**SUBJECT:** Distribution of: **Kelly Aerospace Service Bulletin No. A-107A**

Bulletin No. A-107A

**SUBJECT:** Inspection of Fuel Regulator Shutoff Valve as Used With Kelly Aerospace Combustion Heaters, Models B1500-B4500

**SUMMARY OF REVISION:** This revision of Kelly Aerospace Service Bulletin No A-107 incorporates modifications to the pressure test procedure described in Sections 3 and 4. Recurrent inspection requirements are added to Section 7. A dark highlight bar in the left-hand margin denotes change locations.

**Figure 2**

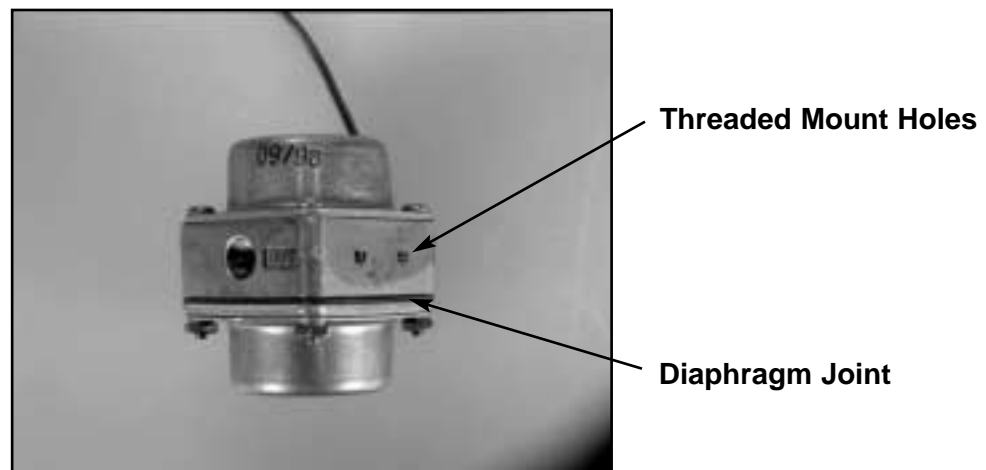
Recent field reports have indicated the possibility of fuel seepage at either the diaphragm joint or threaded mount holes as shown in Figure 2. Within the next 10 hours of operation, inspect the pressure regulator shut off valve for signs of fuel leakage as follows.

- b. Using mineral spirits or JET-A as the test fluid, pressurize the inlet port of the regulator valve to 50 psi for 1 minute minimum with the solenoid energized. Carefully inspect the valve body for signs of fuel leakage giving careful attention to the diaphragm joint and the threaded mount holes as shown in Figure 2. **CAUTION - prior to test, exercise care to wipe valve body and fittings free of any residual fluid that may have contacted external surfaces of the valve during test setup.** Leakage may appear as a wetness or seepage at the diaphragm joint or threaded mount holes. Rotate the valve during pressure test as necessary to fully inspect all external surfaces.

- 5) Visually inspect the valve body for signs of fuel stains, paying careful attention to the diaphragm joint and the threaded mounting holes located in sides of the valve body (see Figure 2). Fuel leakage in those applications using AVGAS may appear as a greenish blue stain or residue in the area of the diaphragm joint or threaded mount hole. Fuel leakage in those applications using JET-A fuel may appear as a wetness or oily residue at the diaphragm joint or threaded mount hole. Utilize supplemental lighting if needed to facilitate visual inspection. Visual inspection must include all four sides of the regulator valve body. If signs of fuel leakage are found replace the valve using a new valve of appropriate part number with a manufacture date code of 02/02 or later. Record valve replacement and Service Bulletin compliance in the logbook.

- c. If signs of fuel leakage are found replace the valve using a new valve of appropriate part number with a manufacture date code of 02/02 or later. Record valve replacement and Service Bulletin compliance in the logbook.
